Technical review of mine closure plan and mine closure implementation at Minerales Entres Mares San Martin mine, Honduras

A report prepared for Caritas (Honduras) / CAFOD International by

June 2009

Figure 1. Concentrations of total iron at monitoring point M4 on the Quebrada Casitas. Data collected by DEFOMIN

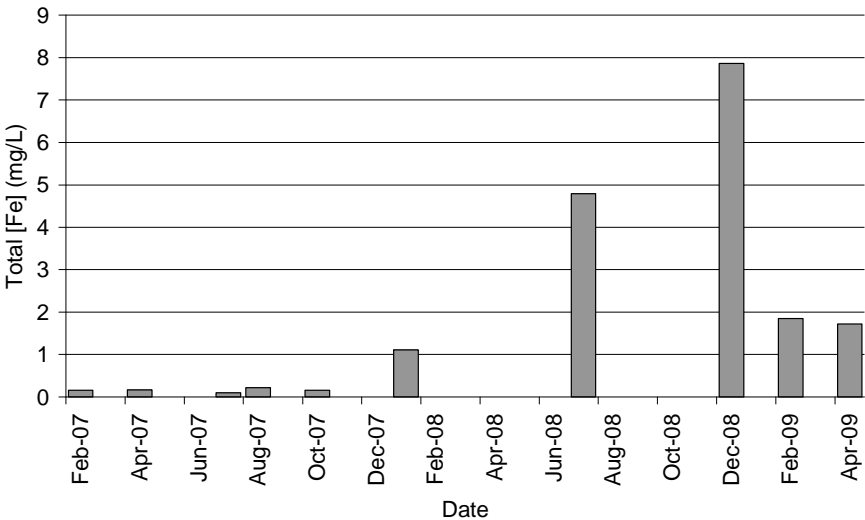
- 1) Periodically elevated concentrations of iron in the Quebrada Casitas (at monitoring point M4), as illustrated in Figure 1 and, of more concern
- 2) A clear, and severe, incidence of AMD on 24 September 2008. The relevant data are shown in Table 1.

Iron is the contaminant most commonly associated with acid mine drainage, since it arises from the oxidative dissolution of the common mineral pyrite. The occasionally high concentrations of iron in the Quebrada Casitas may be related to AMD from the Tajo Palo Alto. However, this is not absolutely certain from the data available. Additional data would be required to confirm whether any future incidences of elevated iron concentrations were associated with discharges from the Tajo Palo Alto (and recommendations for appropriate sampling and analysis strategies are discussed later in this document).

In relation to water quality monitoring, it is recommended that additional sampling locations are monitored, and that the analytical suite is expanded. This recommendation applies as much to the activities of the regulatory authorities as the mine operator. Specifically, to properly assess any AMD arising from the Tajo Palo Alto and its impact on the Quebrada Casitas, it is recommended that:

- The discharge from the Tajo Palo Alto is monitored, as is the Quebrada Casitas upstream and downstream of the discharge point from the Tajo Palo Alto. Samples should be collected from all 3 locations on the same sampling trip to allow direct comparison of results.
